Model: AT-C2.5	Date: 22-Oct-10	No.: RD087001n
----------------	-----------------	----------------

Subject: Firmware Release Note: System/Copy		Prepared by: Y. Taniguchi	
From: 1st Tech Service Sect., MFP/Printer Tech Service Dept			
Classification:	<input type="checkbox"/> Troubleshooting	<input type="checkbox"/> Part information	<input type="checkbox"/> Action required
	<input type="checkbox"/> Mechanical	<input type="checkbox"/> Electrical	<input type="checkbox"/> Service manual revision
	<input type="checkbox"/> Paper path	<input type="checkbox"/> Transmit/receive	<input type="checkbox"/> Retrofit information
	<input type="checkbox"/> Product Safety	<input checked="" type="checkbox"/> Other (Firmware)	<input checked="" type="checkbox"/> Tier 2

This RTB has been issued to announce the firmware release information for the **System/Copy**.

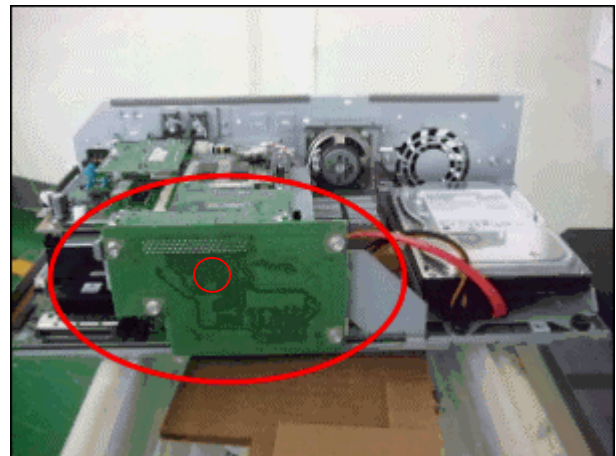
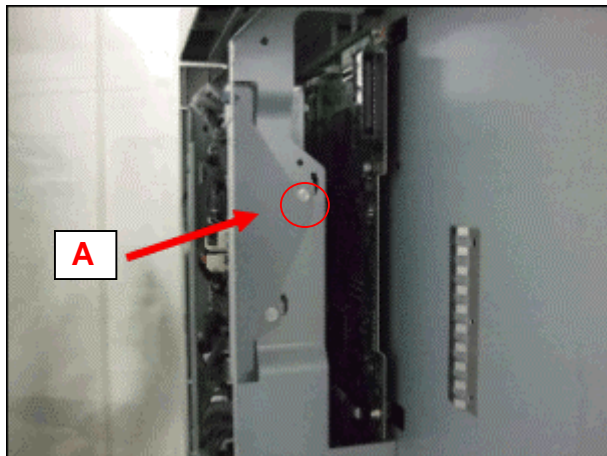
The LCD displays "Please Wait", or the machine does not detect the fax option when the fax option is installed.

The screw [A] shown below touches the fax I/F board, causing a short circuit.

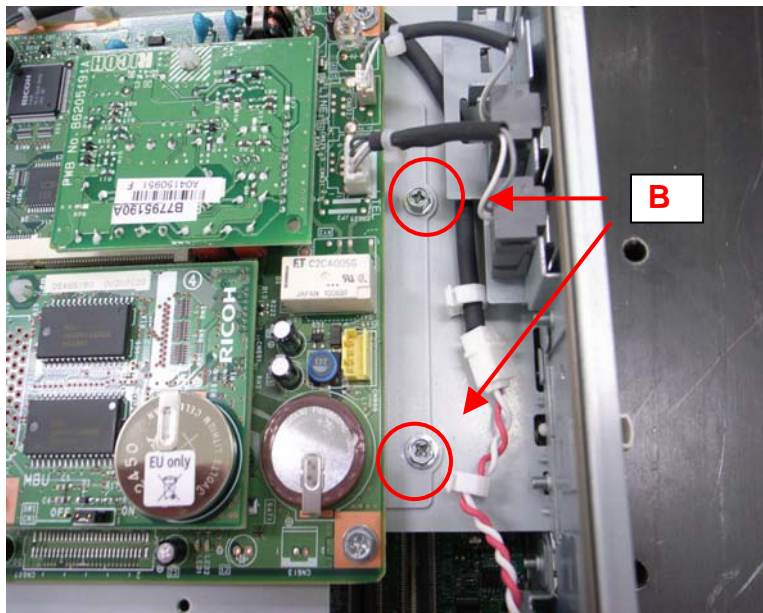
The screw [A] was shortened and the shape of the two screws [B] fixing the plate in place was changed.

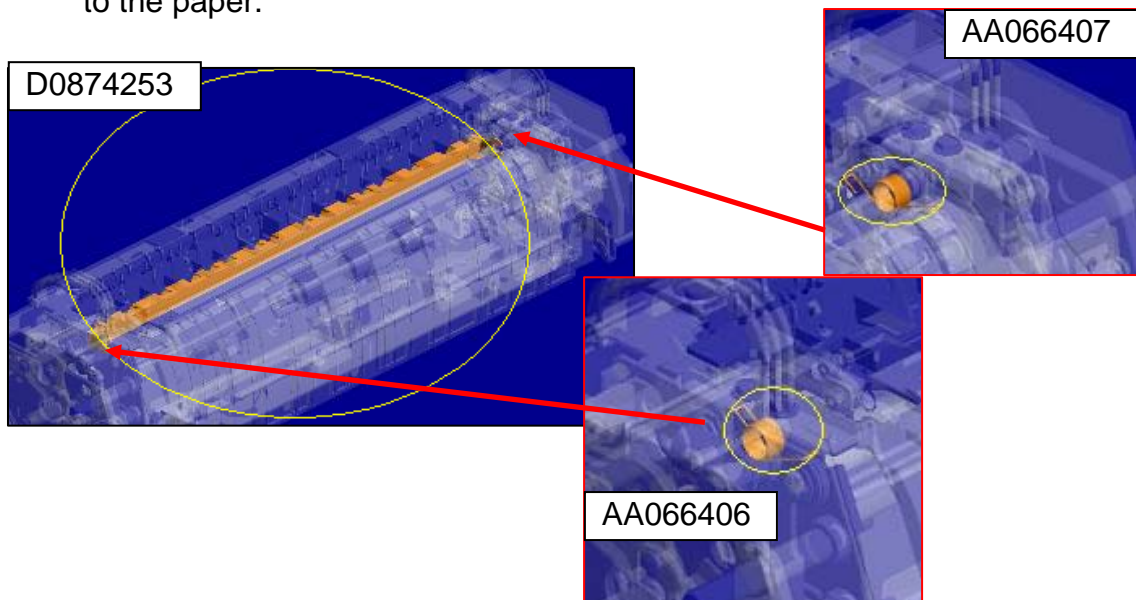
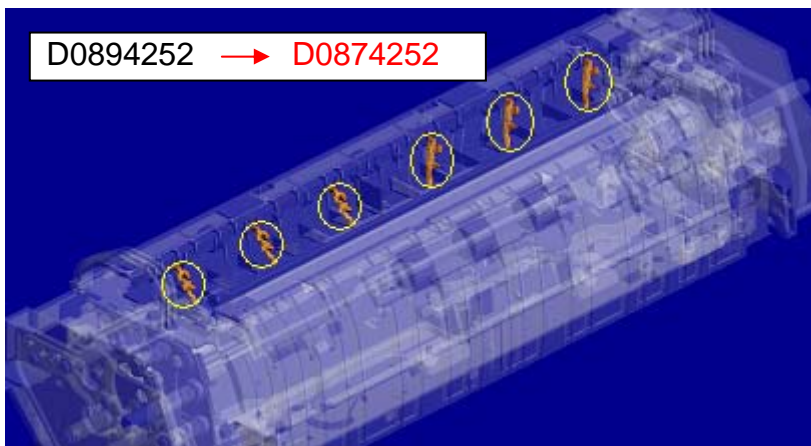
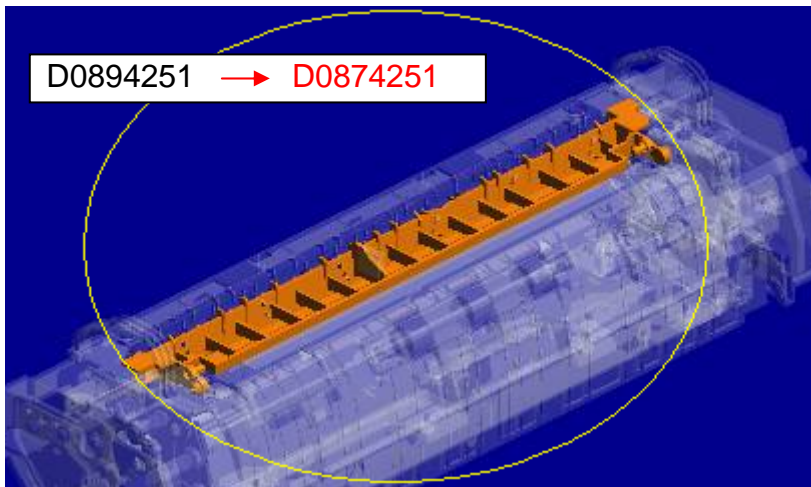
Change: 1) The stripper plate and two of its coils were deleted.

2) The shapes of the fusing exit guide and plate were changed.

Reason: To ensure that condensation that can form on the stripper plate is not transferred to the paper.

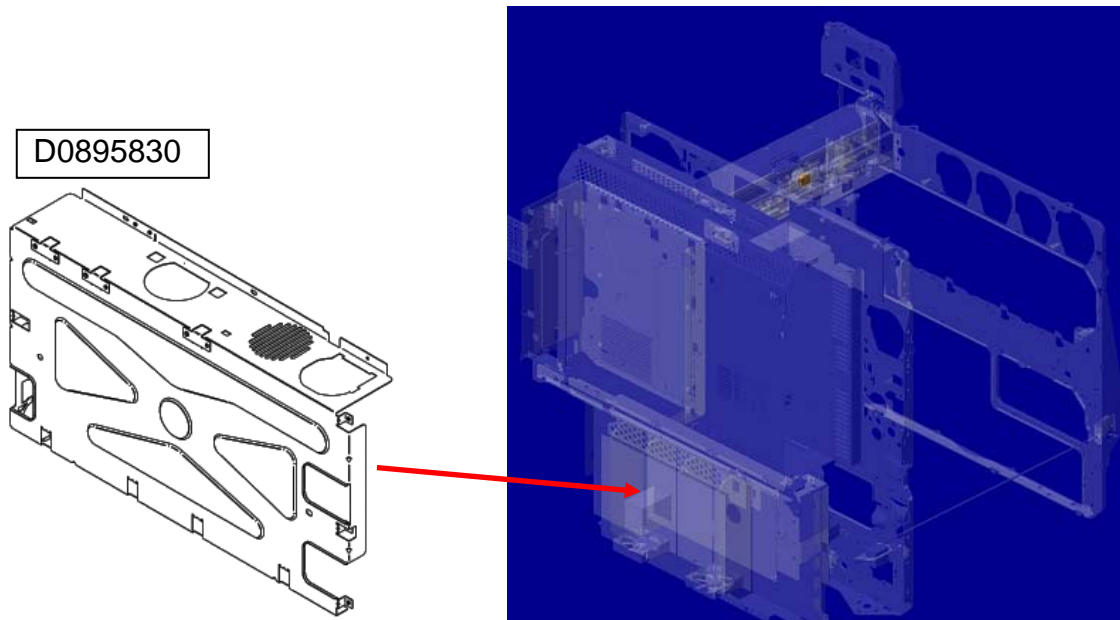
Change: The PSU bracket was added as a service part.

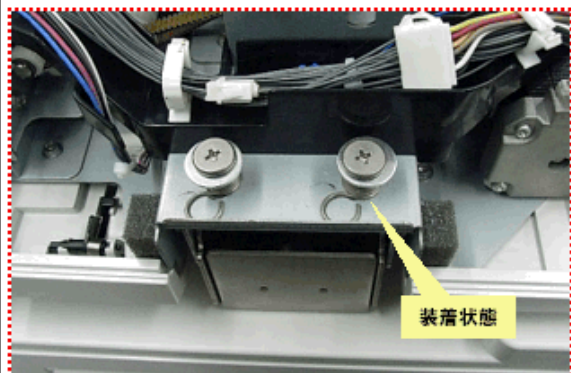
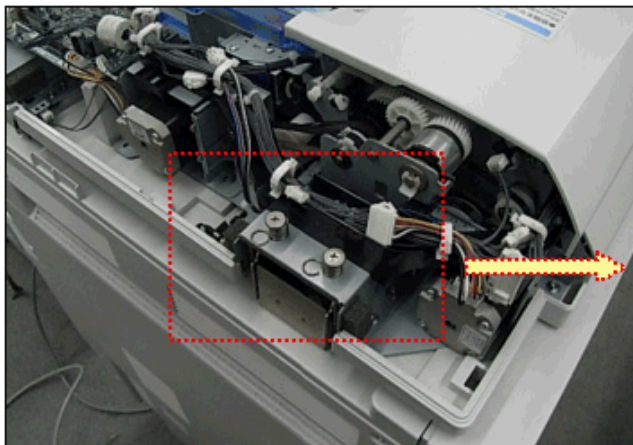
Torque of the hinge increases with time and it can create an imbalance in the pressure applied to the original between the front and rear sides of the ADF.

Remove the following stud screws and reinstall them with a white spacer (07080080N) under each screw.

Replace Hinge: Left (D3661271) with the new part (D5411271).

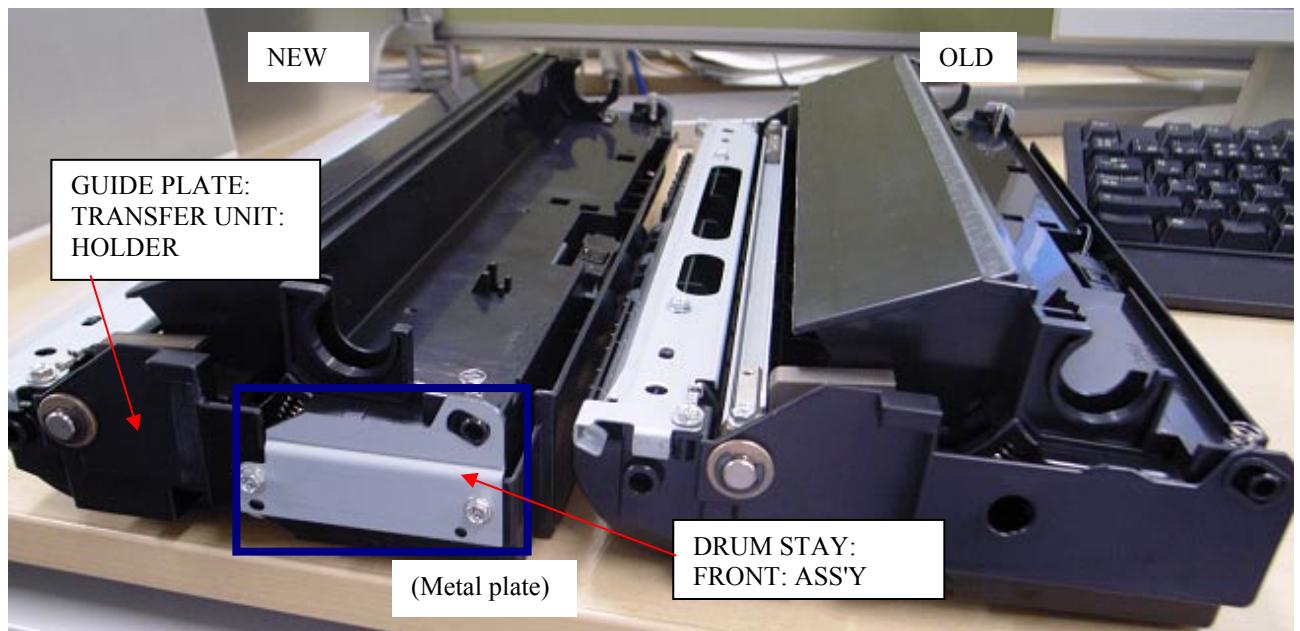
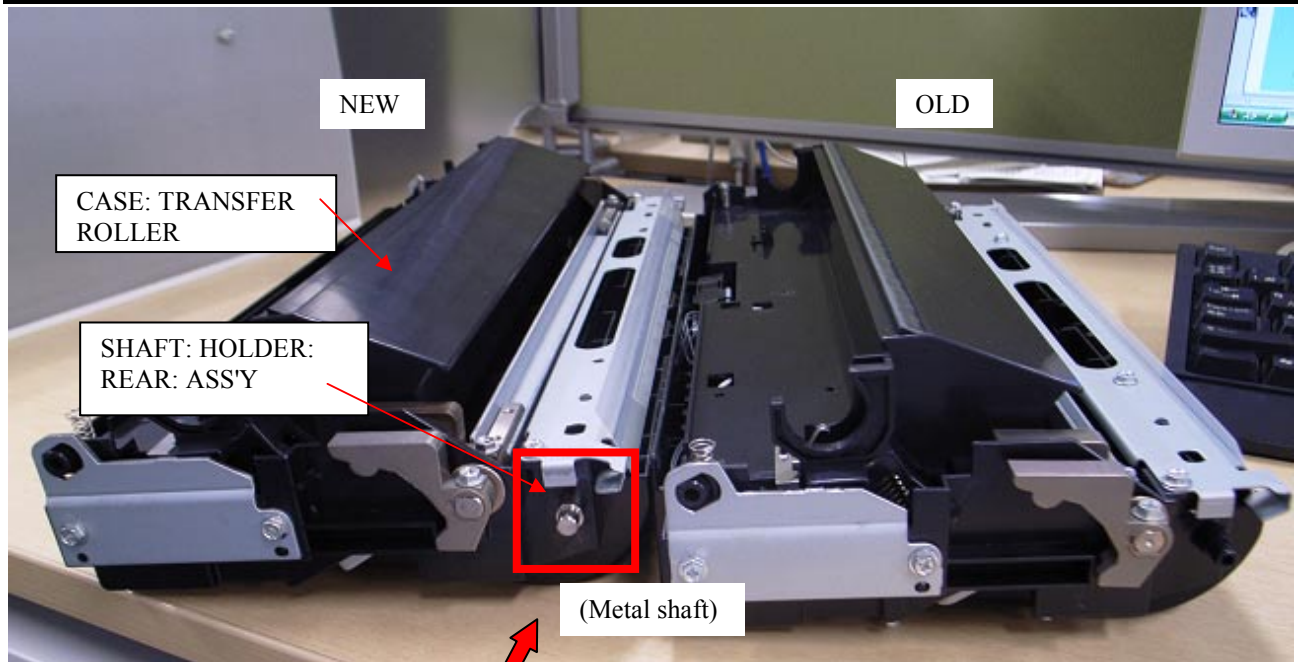
Change: The material of the parts was changed from a resin to a metal.

Reason: To further increase the load-bearing strength of the parts.

Important: Interchangeability is **X/O as a set** (all six parts together).
